IDENTIFICATION OF REFRACTORY MATERIAL FAILURES IN CEMENT KILNS CORRECTIONS

CORRECTIONS EXAMINER 1

CORRECTIONS EXAMINER 2

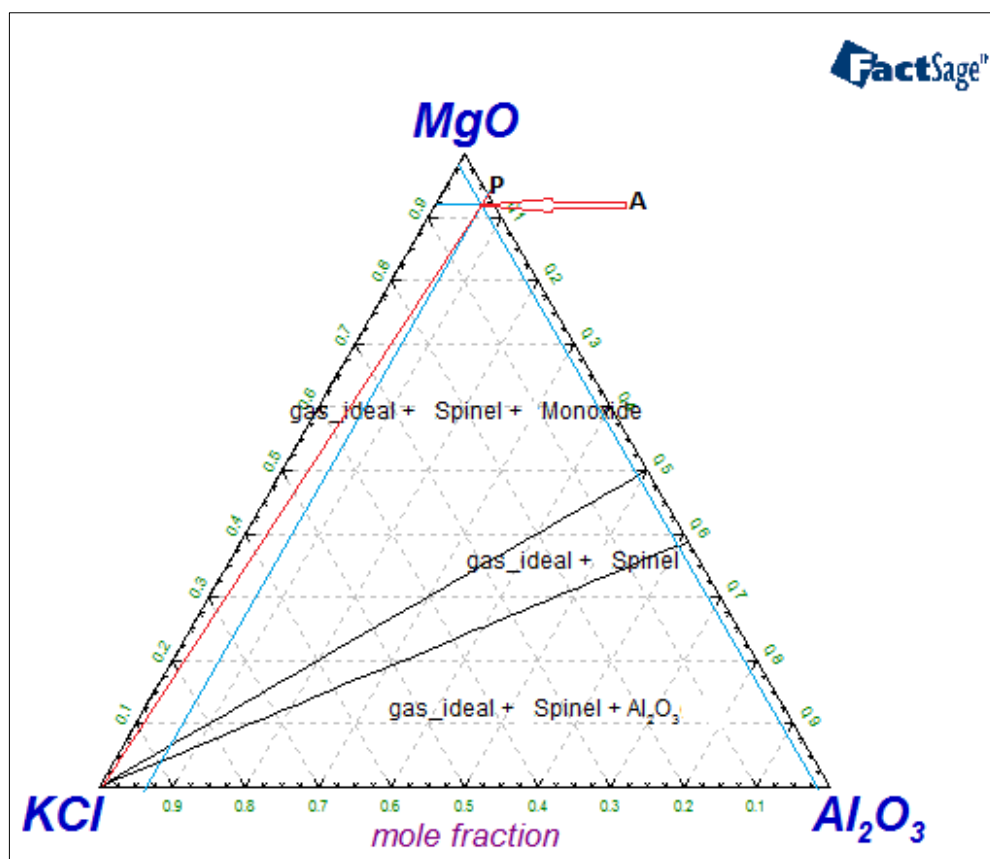
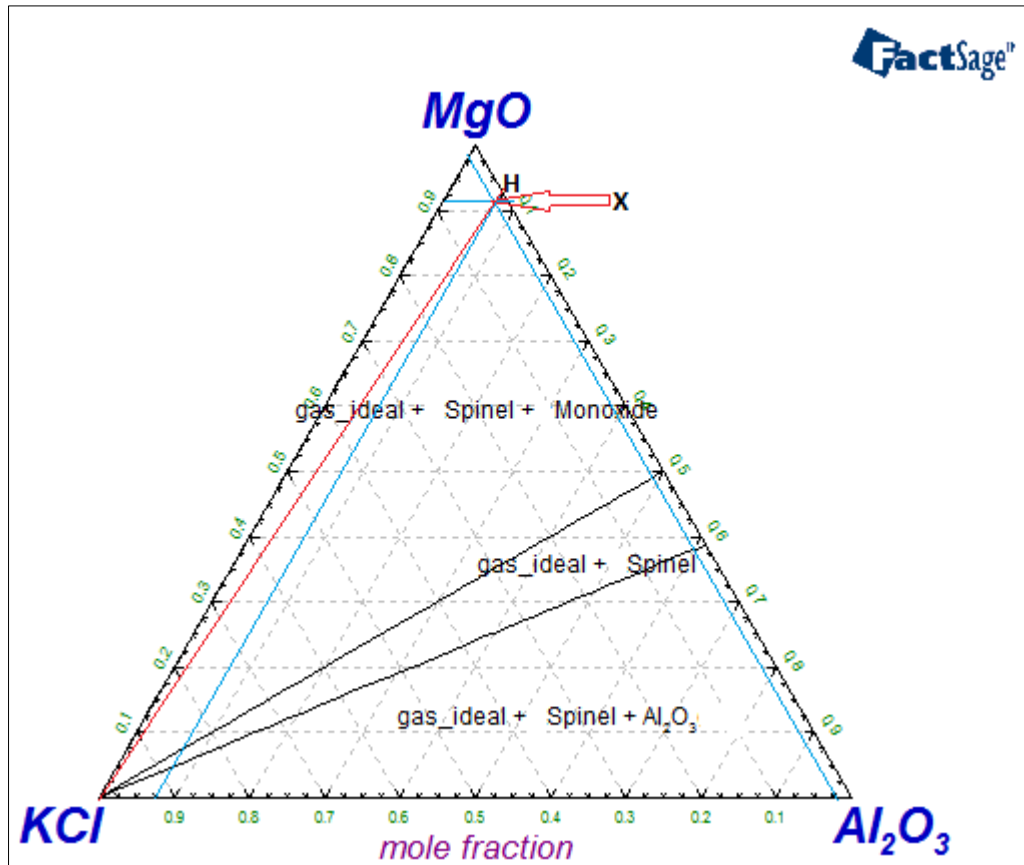
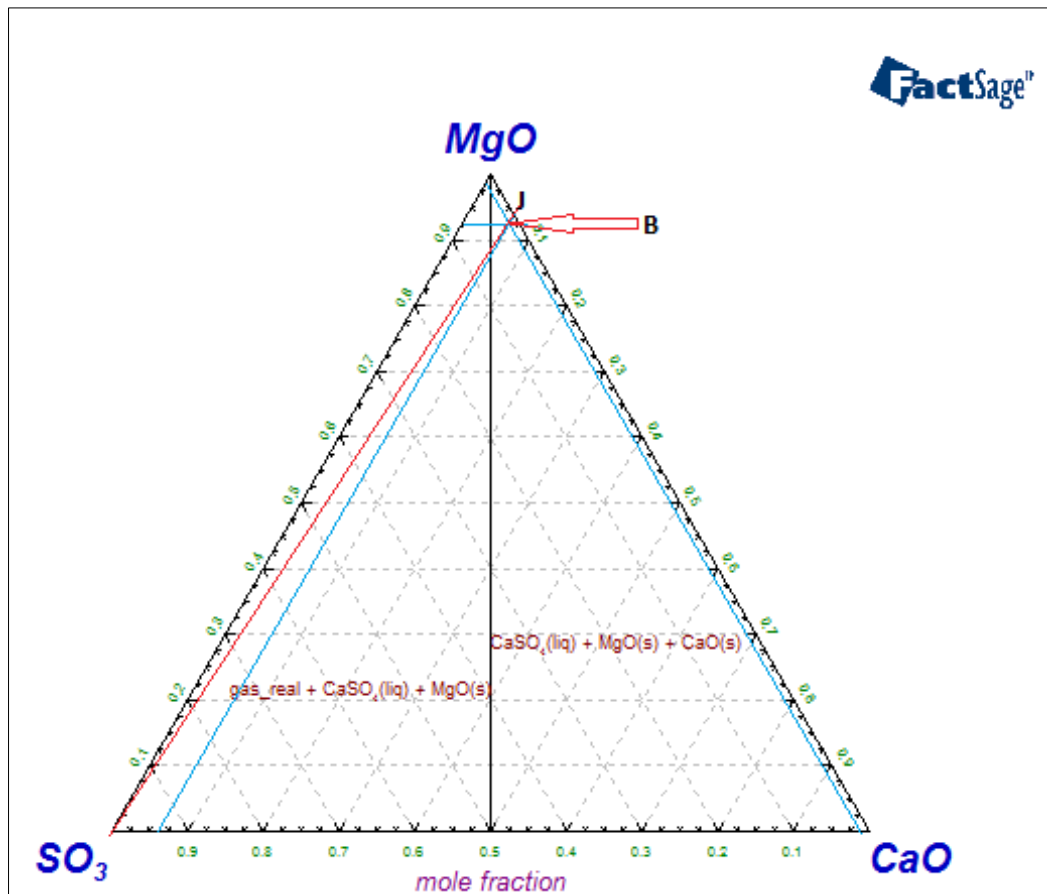
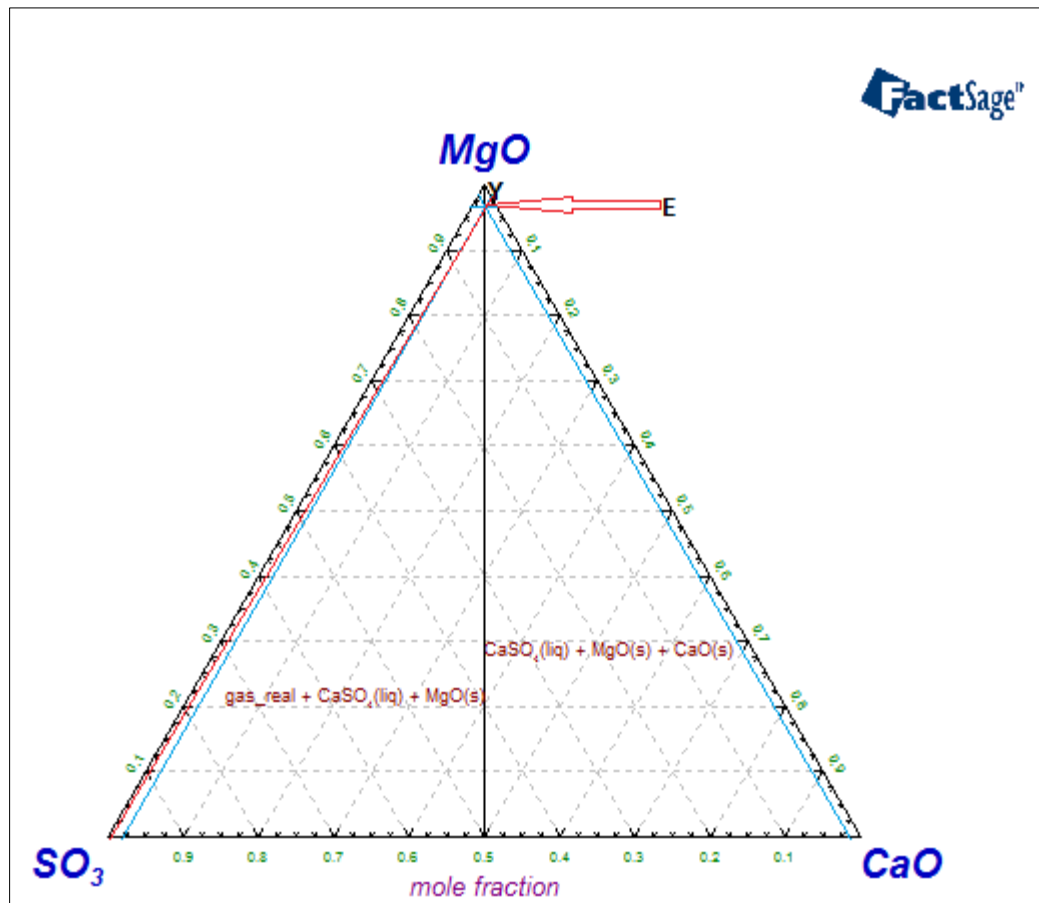
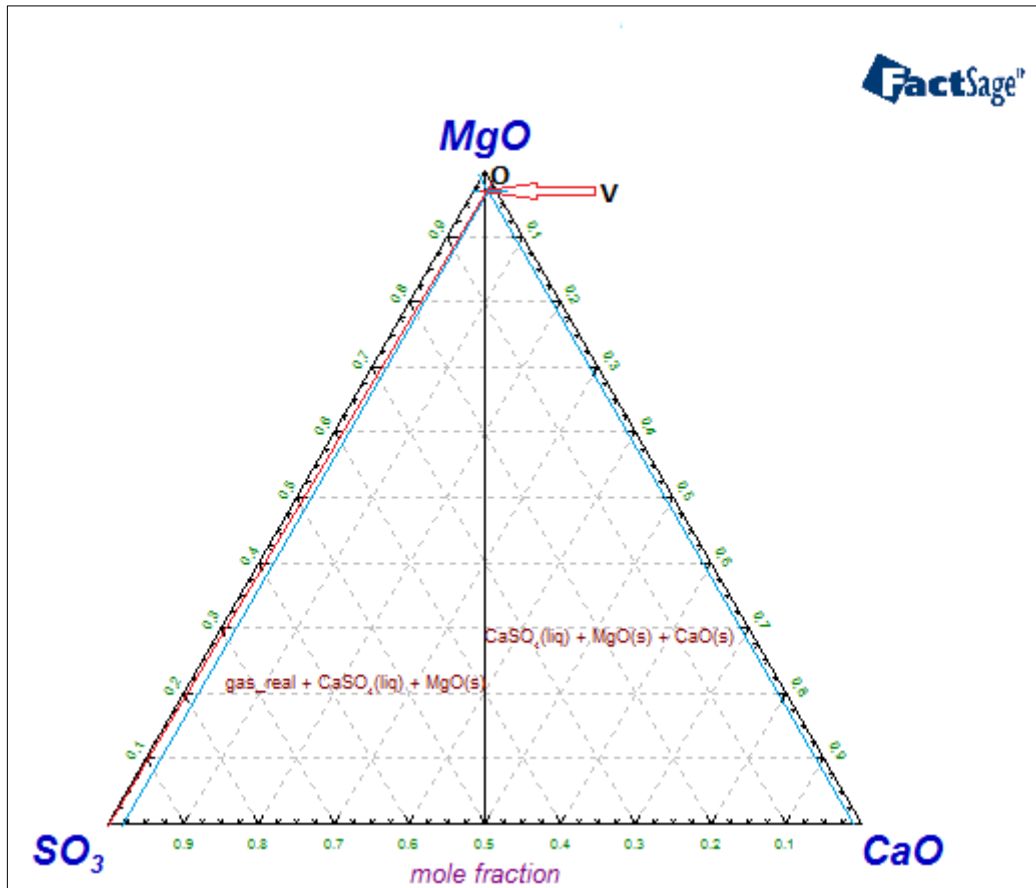
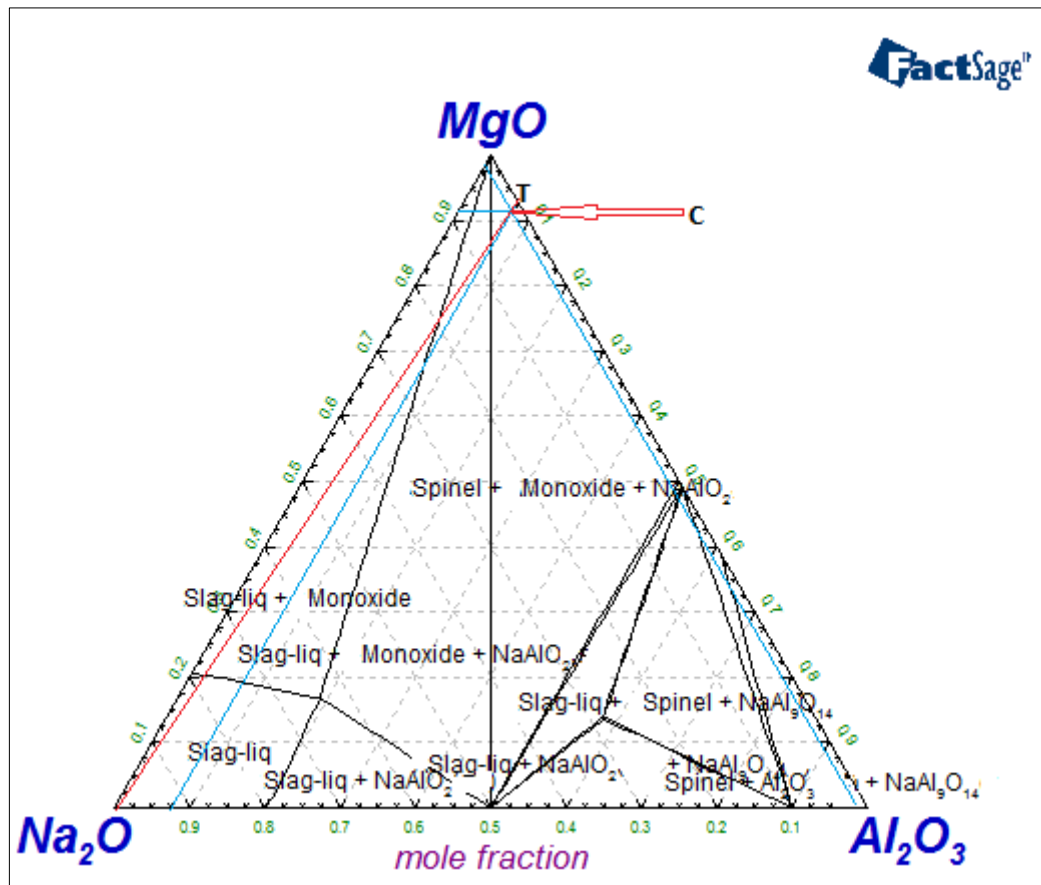
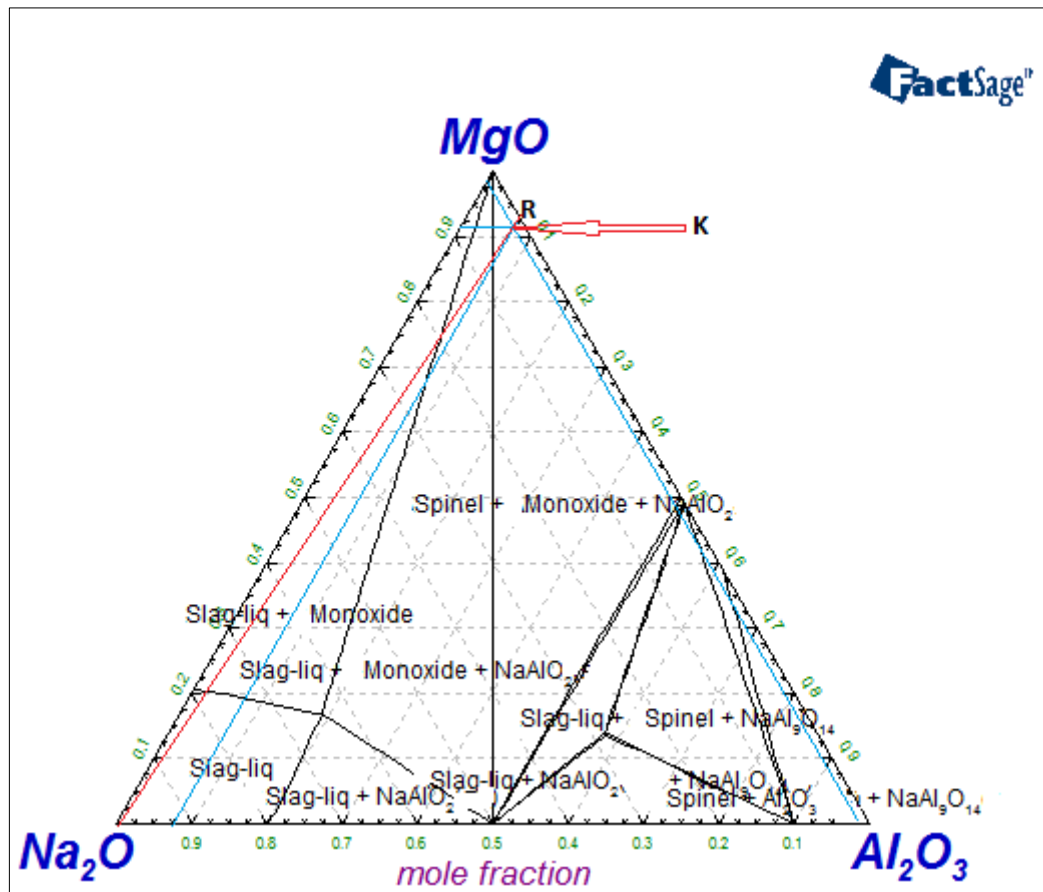
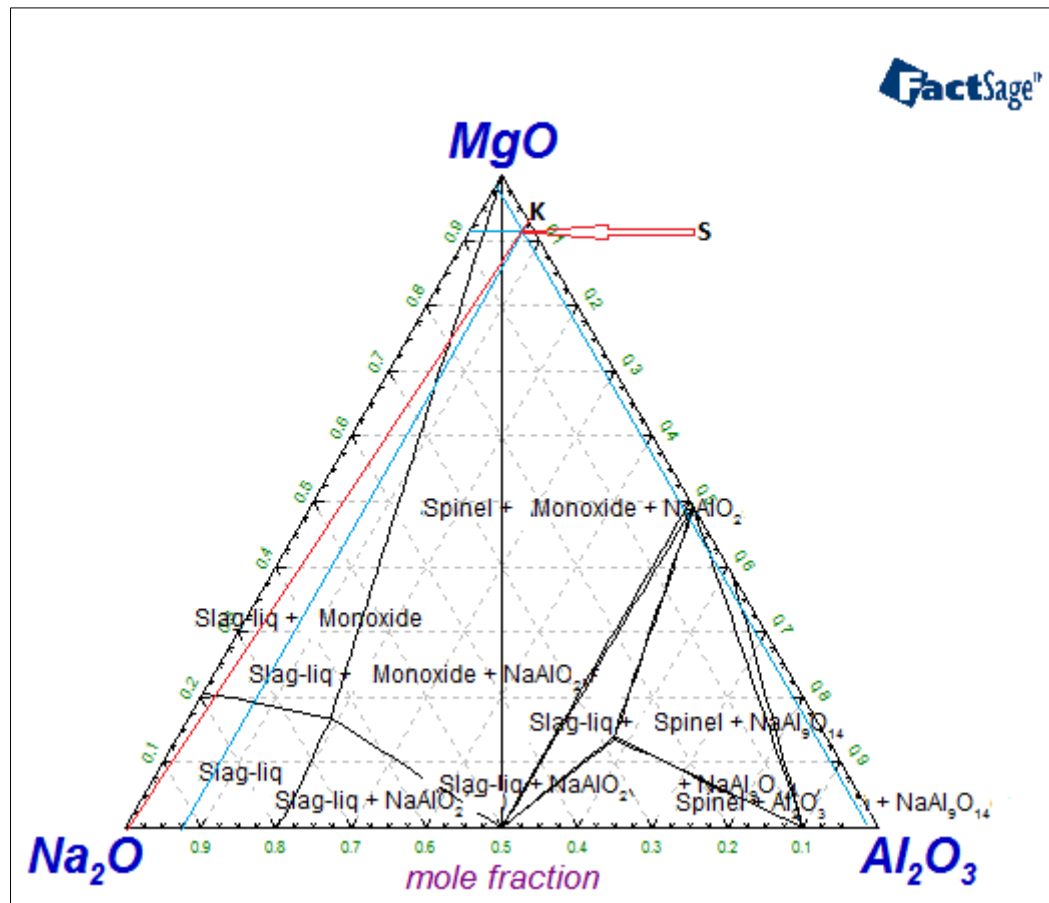
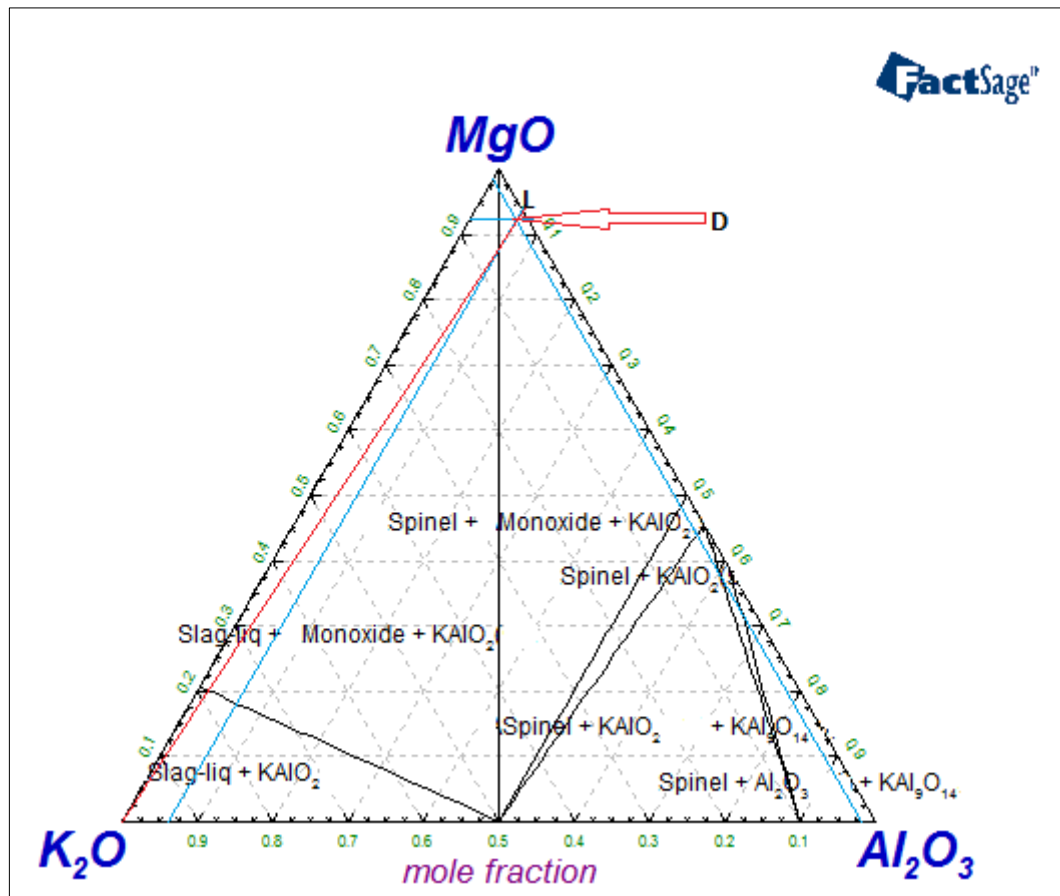
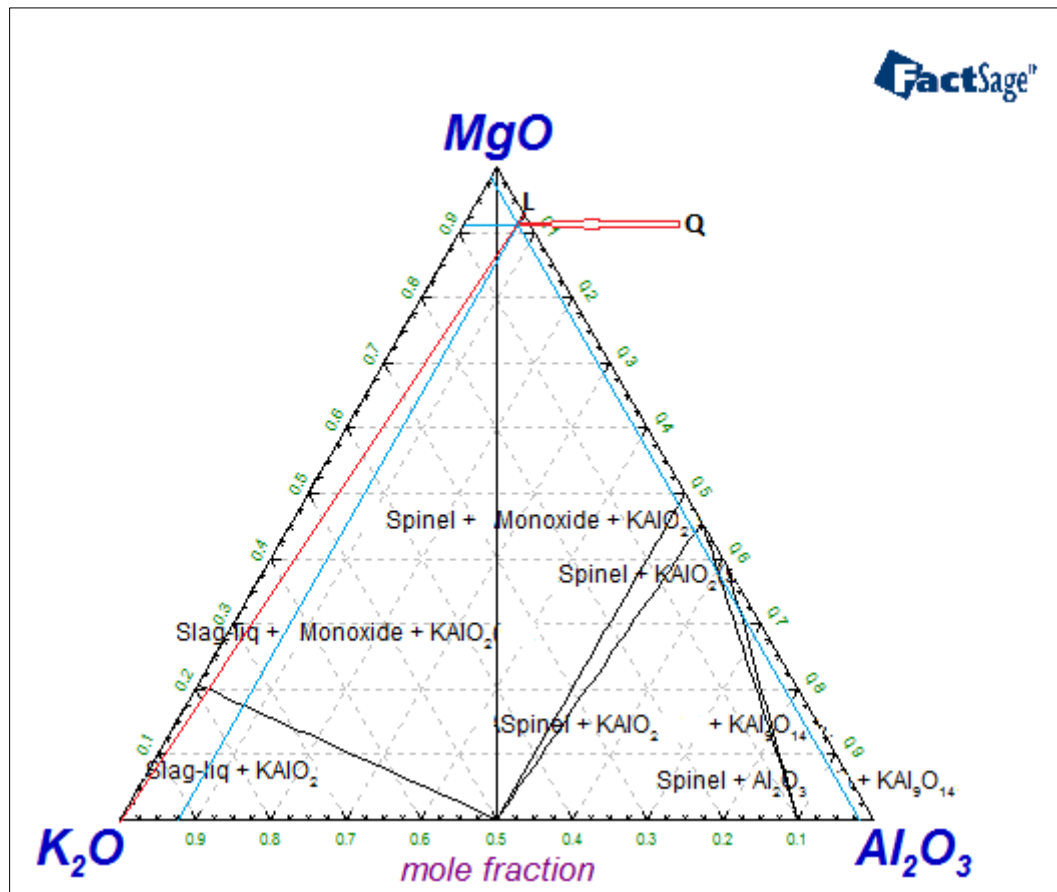
FactSage ternary diagrams. The graphics of all figures containing ternary diagrams generated by FactSage contain title information, which is repeated in the caption. Only the caption should be used, and not the title information in the graphic.

Corrected to the following:
